Subject: 10CFR Part 21 Notification  
Dresser's 3700 MSSV Adjusting Ring Positions

Subject: 10CFR Part 21 Notification  
Dresser Model 3700 Main Steam Safety Valve  
Adjusting Ring Positions

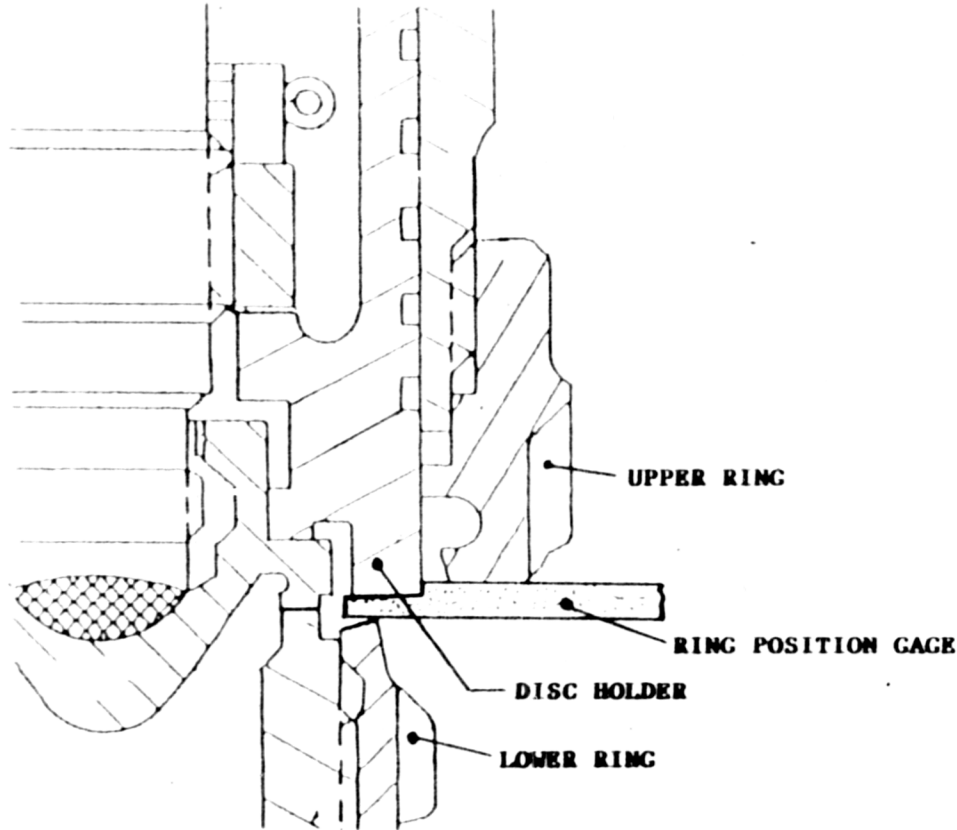
Instructions regarding ring position adjustments found in all previously published editions and revisions to Dresser's 3700 Installation and Maintenance Manual are hereby superceded and the end user should contact Dresser regarding ring positions.

Dresser has developed gauges for positioning the adjusting ring after the valve is assembled. Previously, instructions required the adjusting rings to be positioned during assembly. See sketch attached.

1. LOOKING INTO THE VALVE OUTLET, PLACE THE GAGE UP AGAINST THE BOTTOM OF THE DISC HOLDER AS SHOWN. TURN RINGS TO PROVIDE CLEARANCE, IF NECESSARY.
2. WHILE HOLDING THE GAGE IN POSITION, TURN THE UPPER RING DOWNWARD UNTIL IT CONTACTS THE GAGE AND RAISE THE LOWER RING UNTIL IT CONTACTS THE GAGE. REMOVE THE GAGE.
3. RE-INSERT GAGE. THE GAGE SHOULD SLIP-IN EASILY. IF NECESSARY, REPEAT ADJUSTMENT.
